Technical Memorandum
for
SA3-~~A~~ Contaminated Sediment
Removal Operations

Portage Creek Area Removal
Kalamazoo, Michigan

USEPA Region 5
Emergency Response Branch
77 West Jackson
Chicago, IL 60604

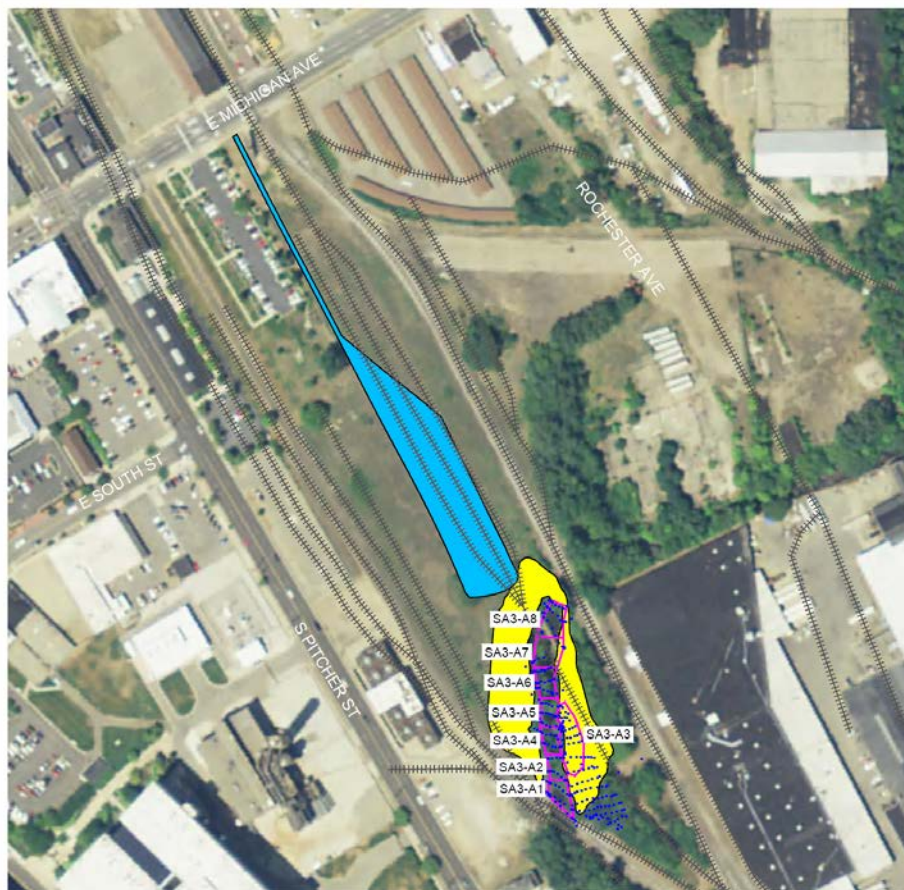
Comment [GU5]: See markup

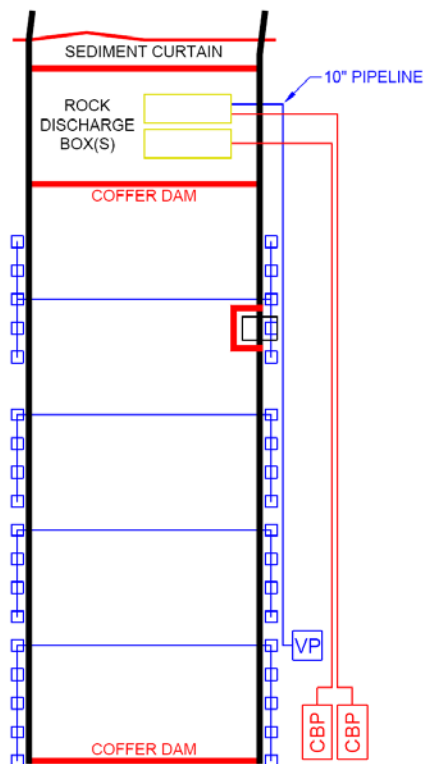
Comment [GU6]: See markup

Comment [GU7]: Remove Figure 5
